On behalf of Clayton Properties Group LLC, CORE Consultants, Aztec, Fox Tuttle Transportation Group, and Terracina Design, we have reviewed the comments from the Second Submission Review for the Prairie Point Golf Site Plan. The following is a response to comments:

Second Submission Review

PRAIRIE POINT GOLF COURSE
AURORA, COLORADO
SITE PLAN
COVER

C IRRIGATION PUMP STATION
Scale: 1"=10'

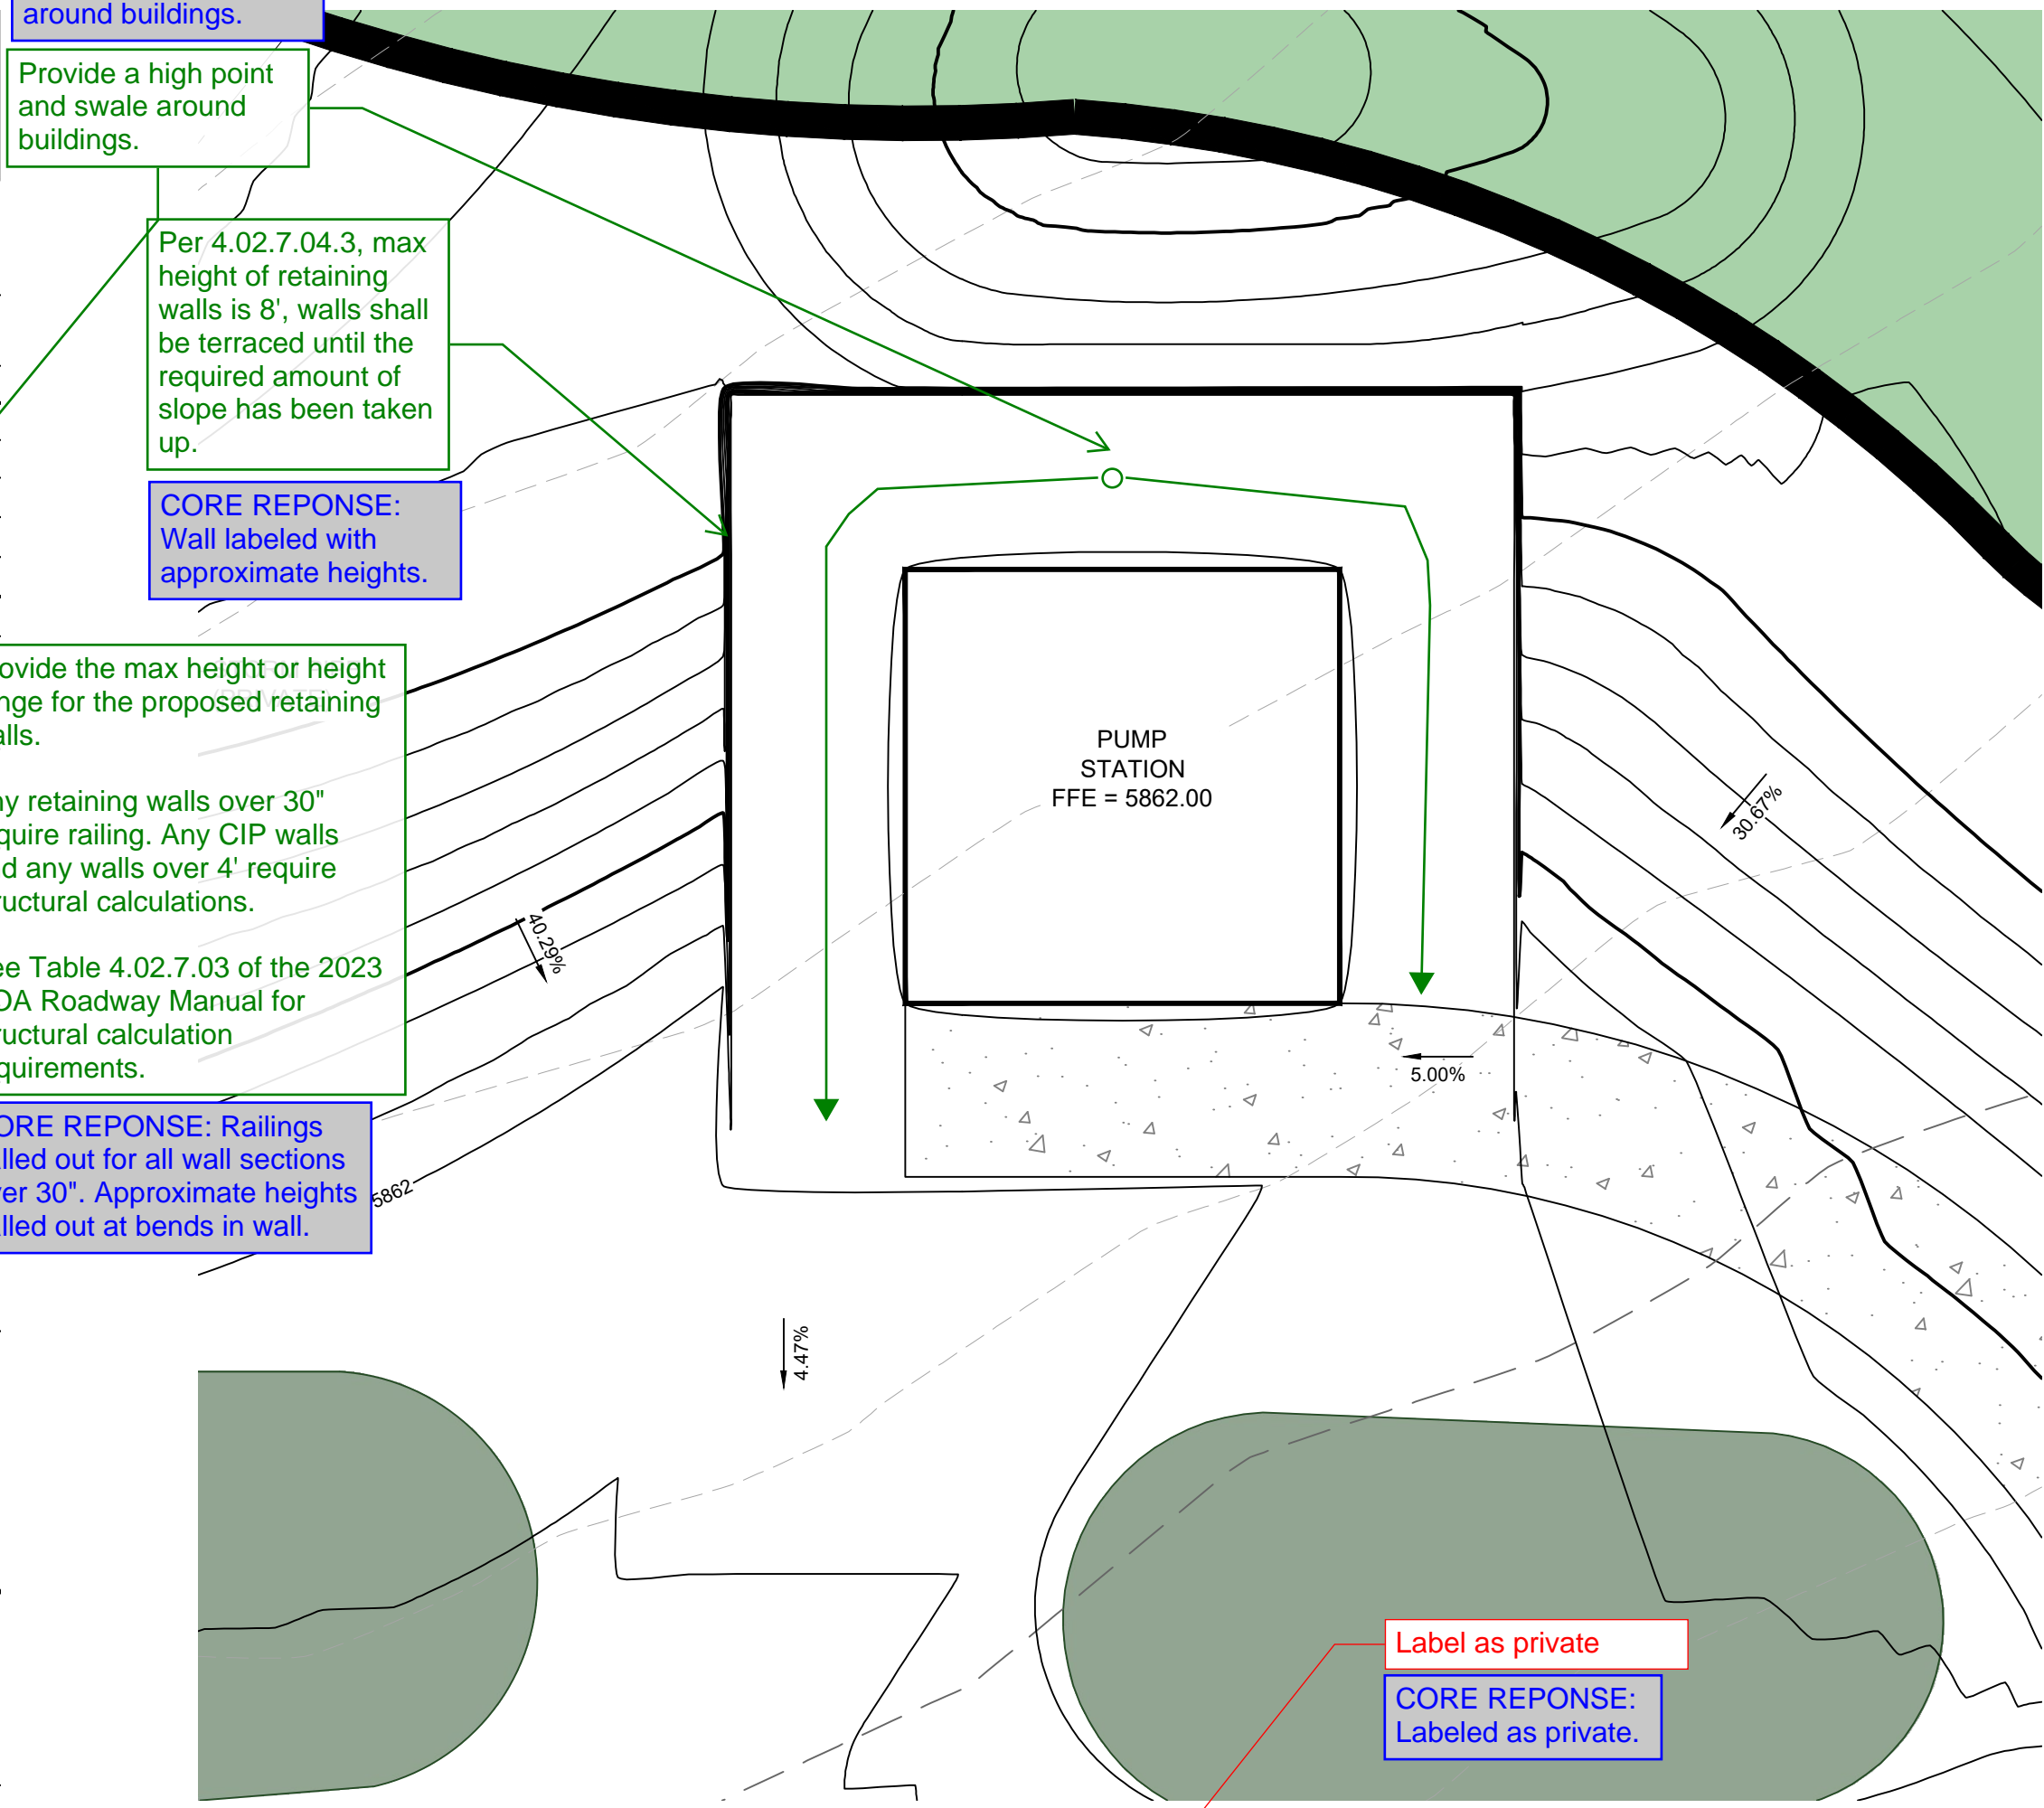
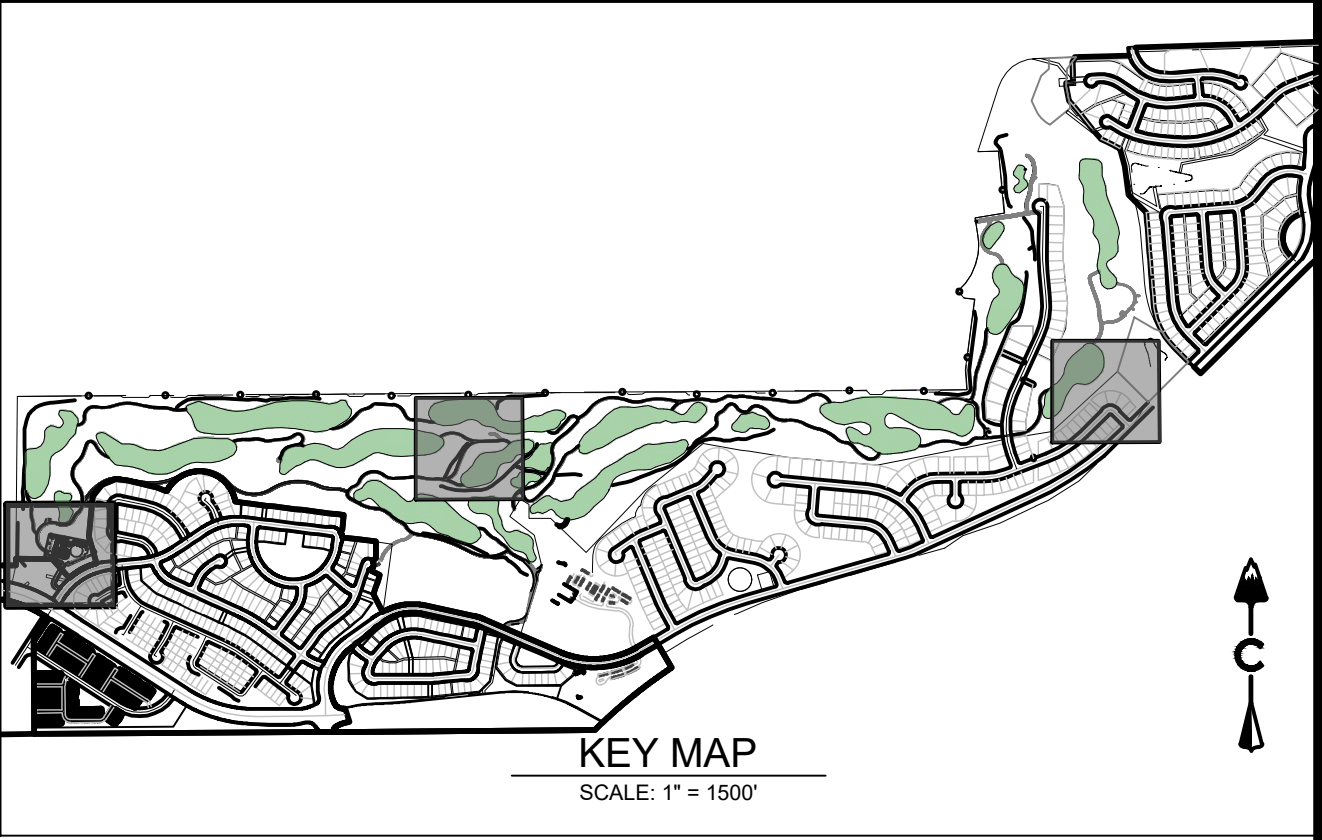
Provide a detailed grading sheet for the maintenance building showing longitudinal and transverse grade percentages through fire lane easement and accessible route.

Provide a high point and swale around buildings.

Provide the max height or height range for the proposed retaining walls.

Minimum slope away from the building is 5% for 10' for landscape areas, minimum 2% for impervious areas. The green shaded area is directed towards the building.

Label slope away from buildings (typ)

CORE REPOSE: Slope labels added to site plan sheet showing maintenance building.

CORE REPOSE: Railings called out for all wall sections over 30". Approximate heights called out at bends in wall.

CORE REPOSE: Grading refined to listed constraints.

1 NO PARKING FIRE LANE SIGN

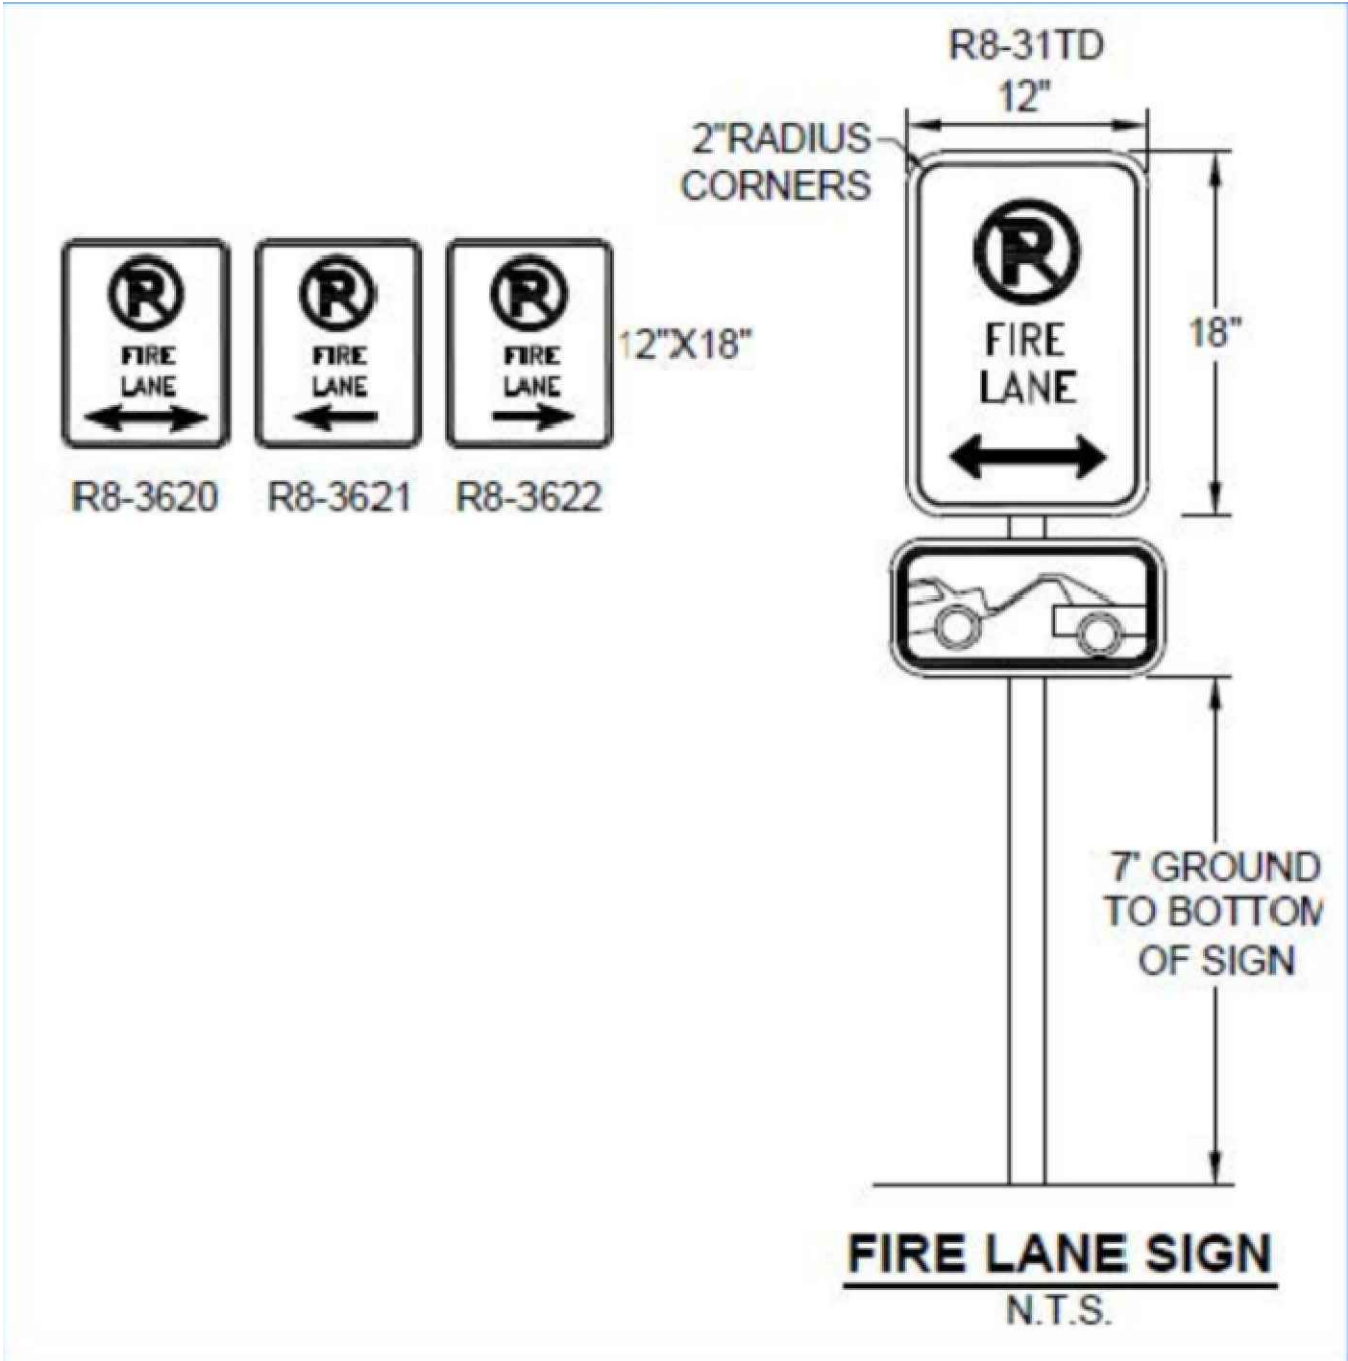
Block out signatures from COA details

CORE REPOSE: Signatures removed from detail.

9 MAINTENANCE GATE
SCALE: NTS

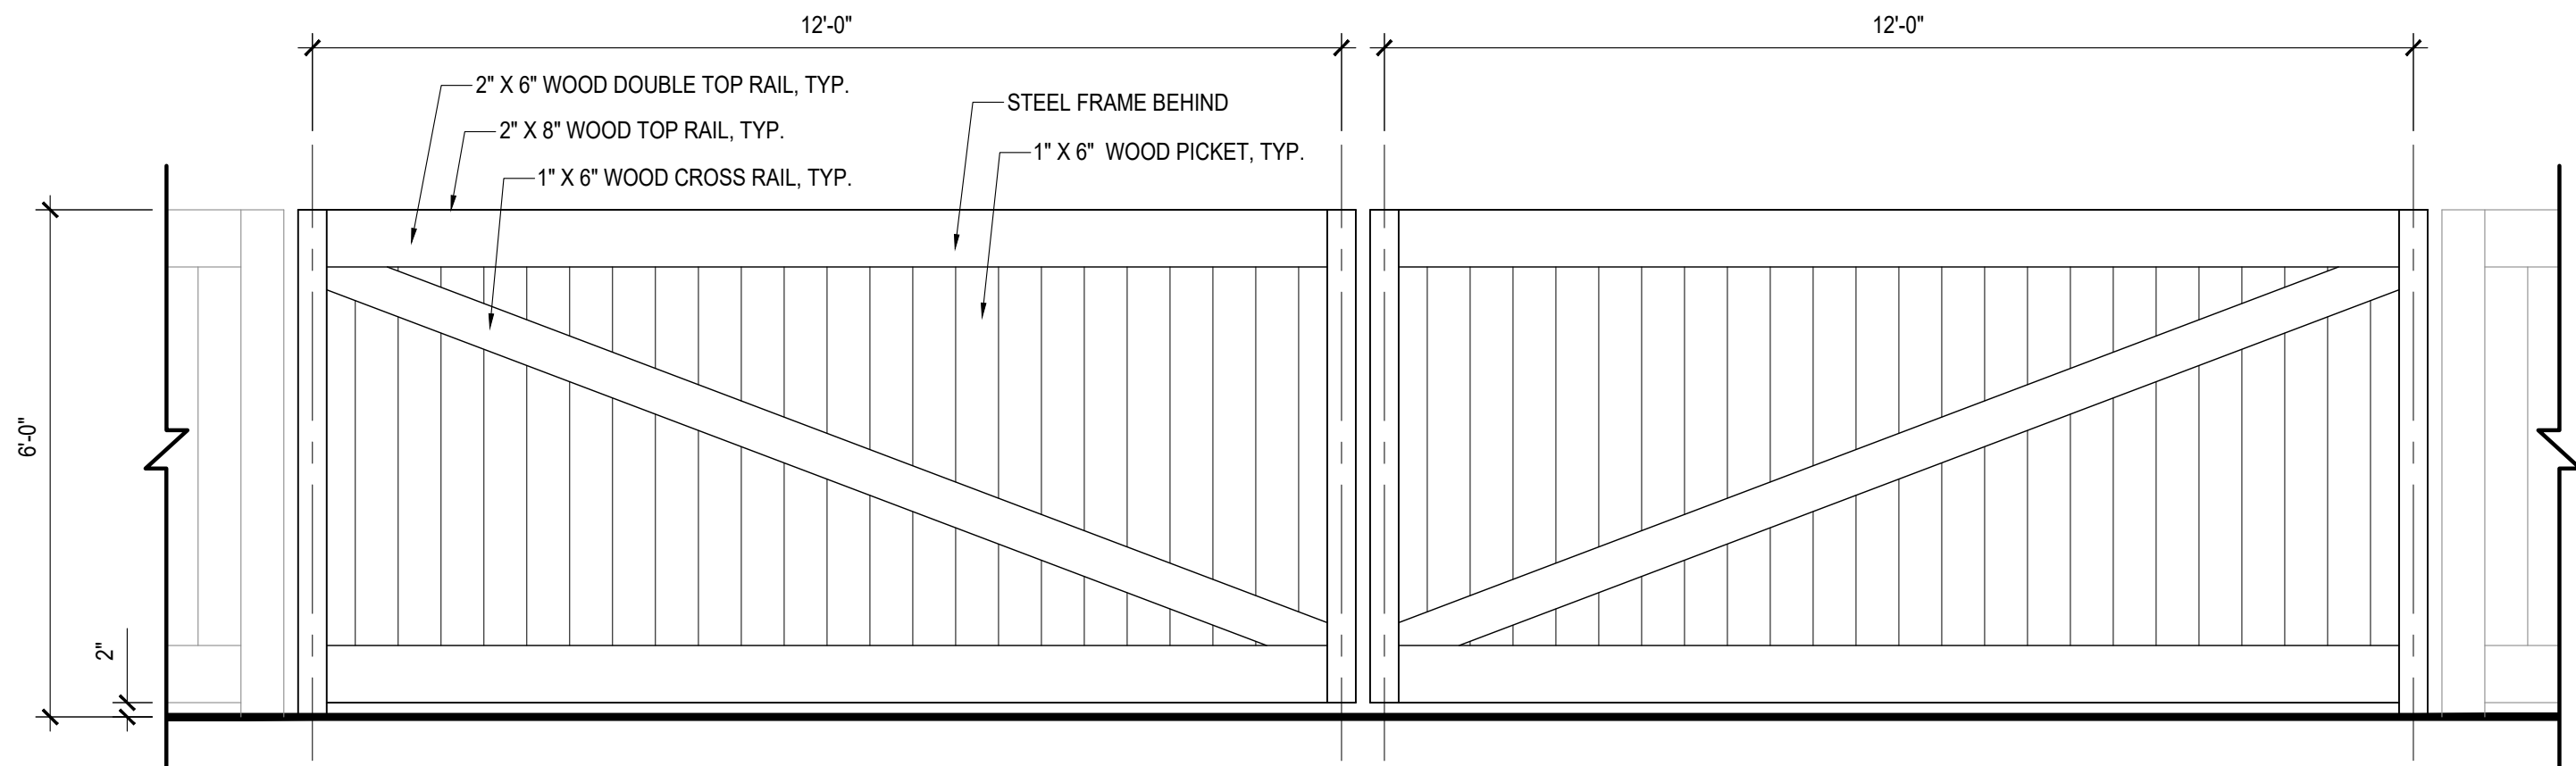
See gating notes on sheets 7 and 32.

RESPONSE: NOTED.

Knox Box

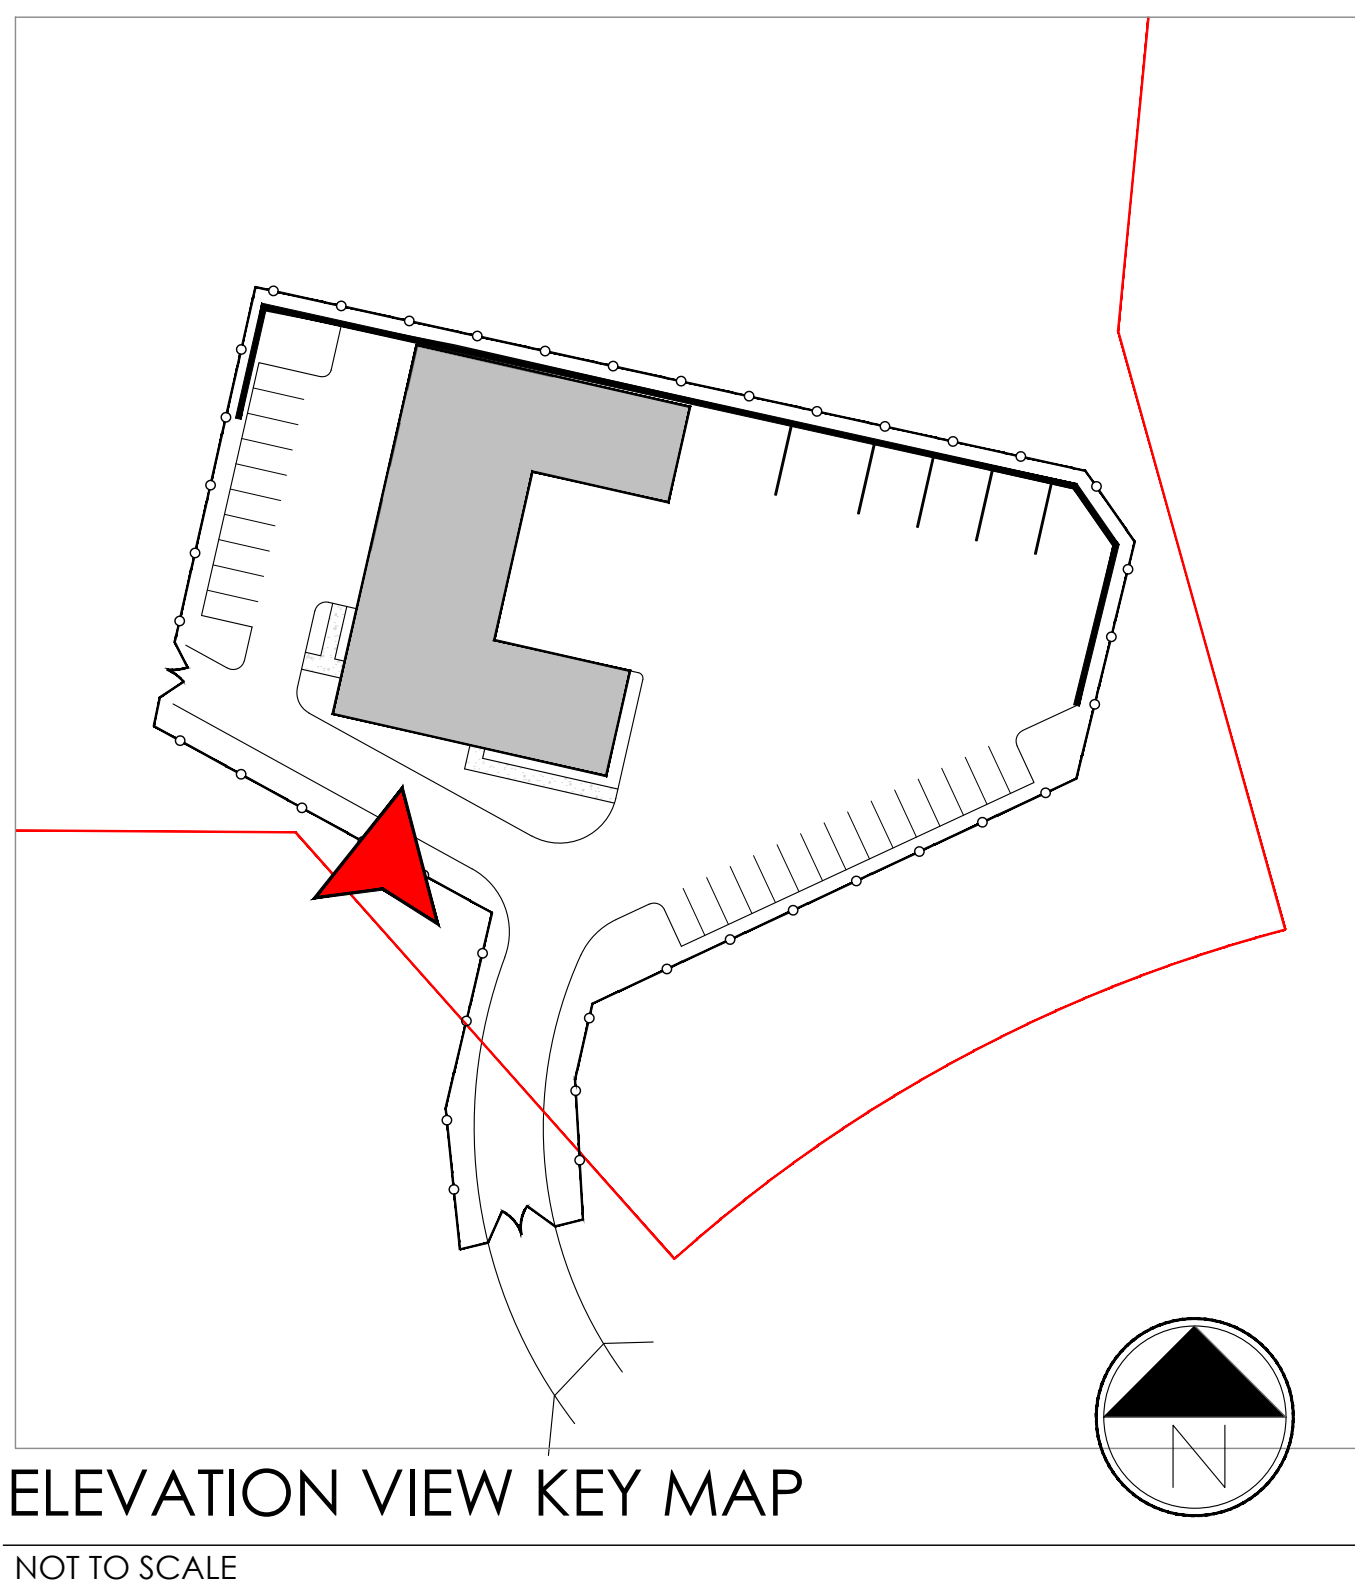
- Knox boxes must be installed within six (6) feet of either side of the entrance door/gate. Knox boxes must be visible and accessible.
- Knox boxes cannot be lower than four (4) feet or higher than six (6) feet above the ground.
- Knox hardware information can be found at our city website at Auroragov.org by typing in "Knox Rapid Entry Systems" in the search tool.

RESPONSE: Labels where added to site plan sheets. Know box was added to gate detail on sheet 33.
